Global technical regulation No. 7 (Head restraints)

Draft amendment 1 (Phase 2 of the global technical regulation)

Submitted by the informal working group on the Phase 2 of the global technical regulation No. 7*

Figure 10-1

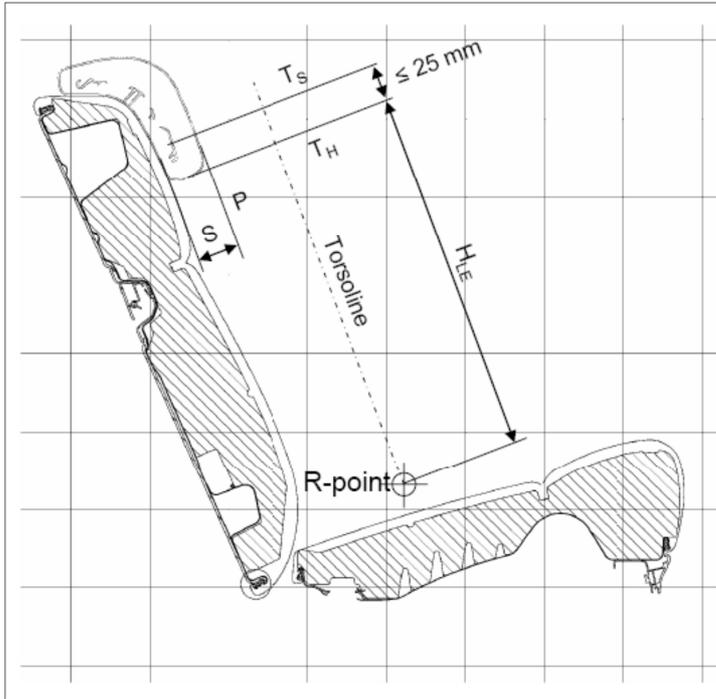
Commented [AS37]: The torsoline on this sketch is actually corresponding to the design torso angle. It should not be called "torsoline" because torsoline has a different definition.

Figure - Three dimensional reference system

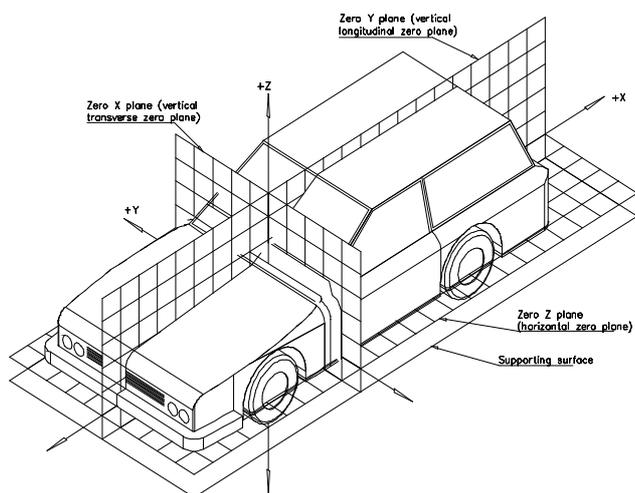
[Need to clarify "forward" from annex 5]

Figure 11-2
[Dimensions of the 3-D H machine elements and load distribution (Dimensions in millimetres)]

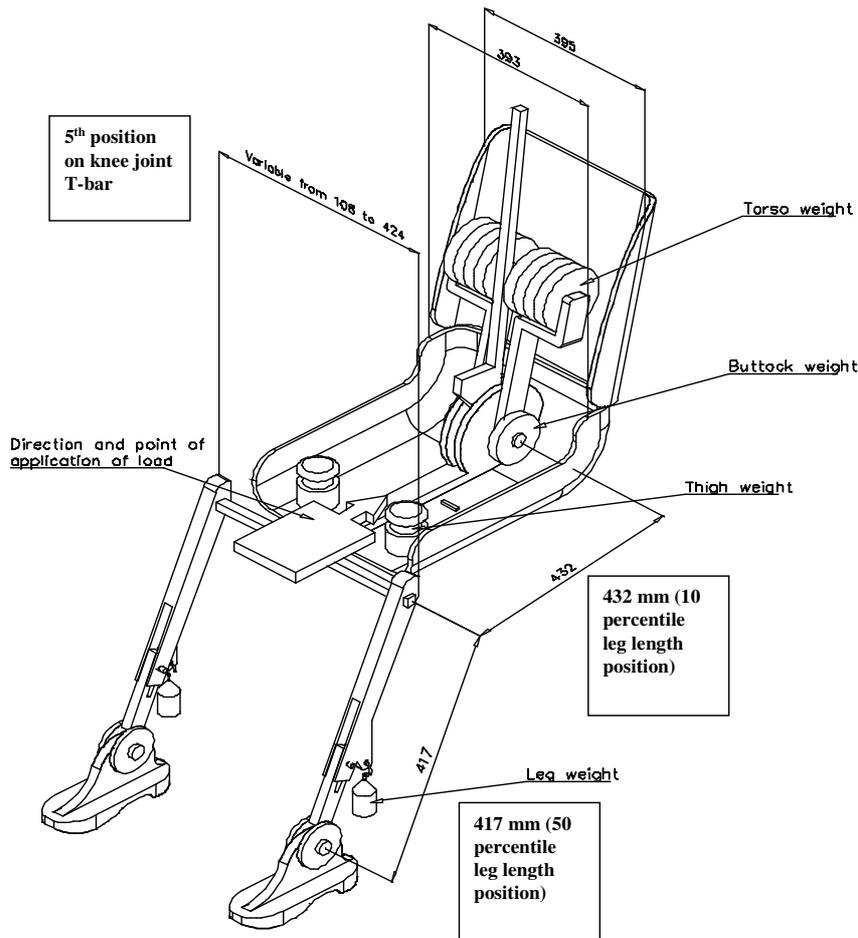
[Latest SAE dimensions for preferred shell width (narrower) favoured: consider implications for other regulations employing 3-DH machine.]
